**URGENT Field Safety Notice**

Azurion 7 M20 FlexArm system with Maquet Magnus Table  
 Unavailable Motorized Table and/or FlexArm Movement Potentially Resulting in Delay or Termination  
 of Procedure.

08-DEC-2023

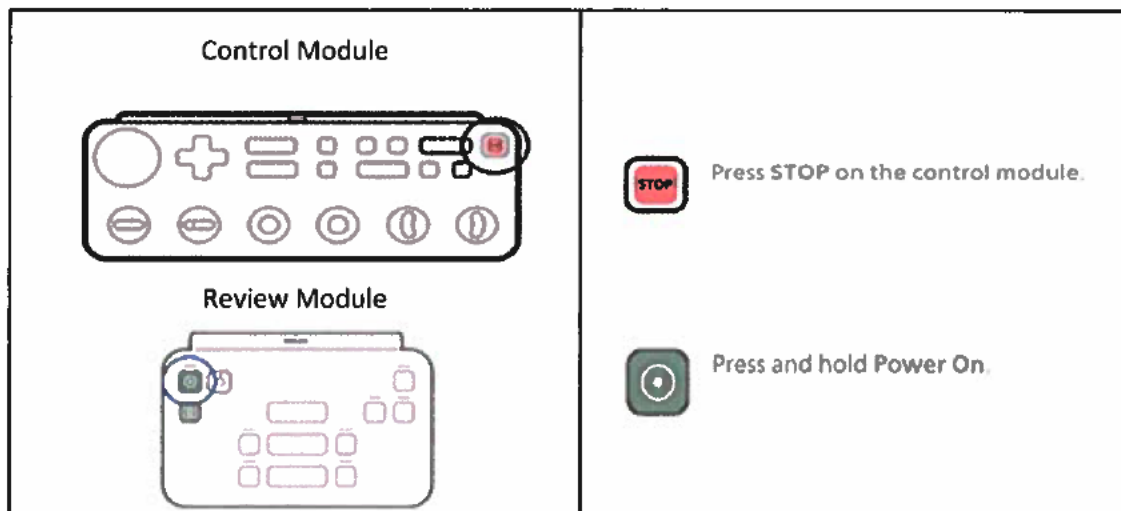
- Until Philips implements the solution in your system. during the procedure:
  - a) Avoid positioning the detector at approximately four (4) cm from the patient.
  - b) If the Connection Issue occurs, perform the following actions in **sequential order**:
    1. move the detector so that it is no longer at approximately four (4) cm from the patient.
    2. if moving the detector doesn't resolve the issue, restart the geometry of the FlexArm as follows:
      - o Press 'STOP' on the **Control Module**
      - o Press and hold the 'Power On' button on the **Review Module**

After this, both Table movement and FlexArm motorized movement will become available again.
